Service Bulletin

Bulletin No.: PIC5973

Subject: Diagnostic Tip - Rear Toe Adjust Link Dampener Service Guidelines

Models: 2010 - 2014 Buick Lacrosse (built prior to 02/19/14)
equipped with 4 Link Rear Suspension (RPO GNC)

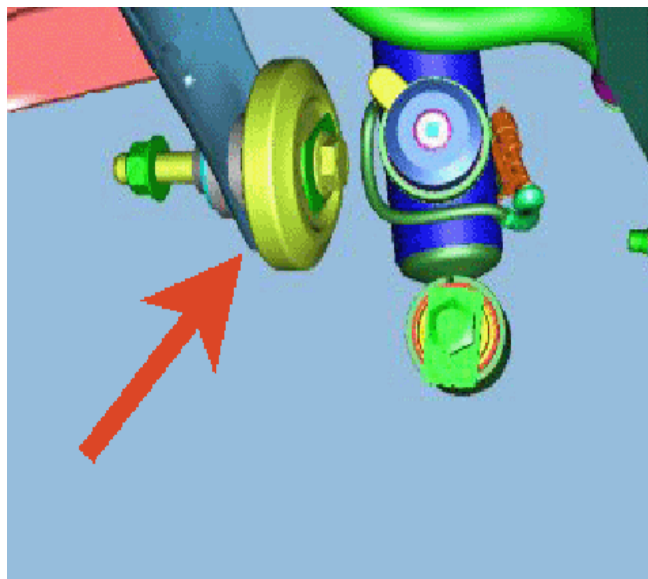
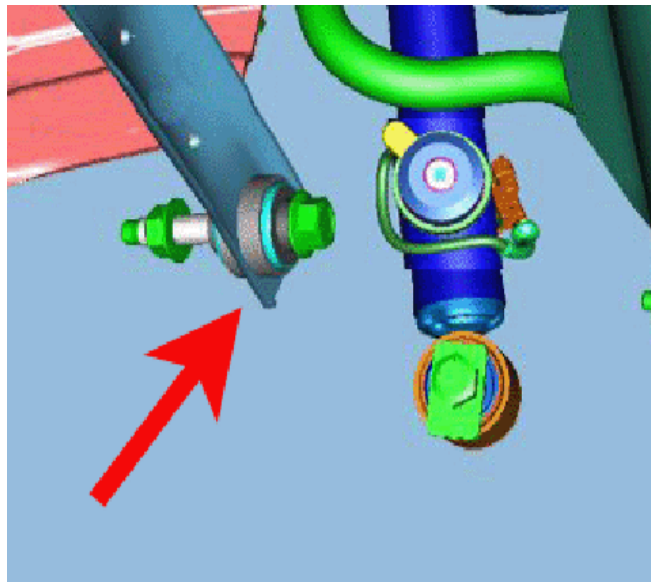
Vehicles listed in the Models section above were built with a dampener on the rear toe adjust link - as reflected in the first image below.

Engineering has determined that this dampener does not make a noticeable impact on noise, vibration, or harshness. Therefore, it has been eliminated from production in February 2014.

The two photos below show the link with and without the yellow dampener. The second image below shows the shorter bolt without the dampener and washer.

If making a repair on a vehicle in which this dampener has been damaged or needs to be replaced, you may remove the dampener and washer and replace with a shorter bolt (GM P/N 11561300). The nut remains the same. Discard the factory-installed dampener and washer.

Note: It is also acceptable to have a dampener on one side only if the other side was unaffected during a particular repair.
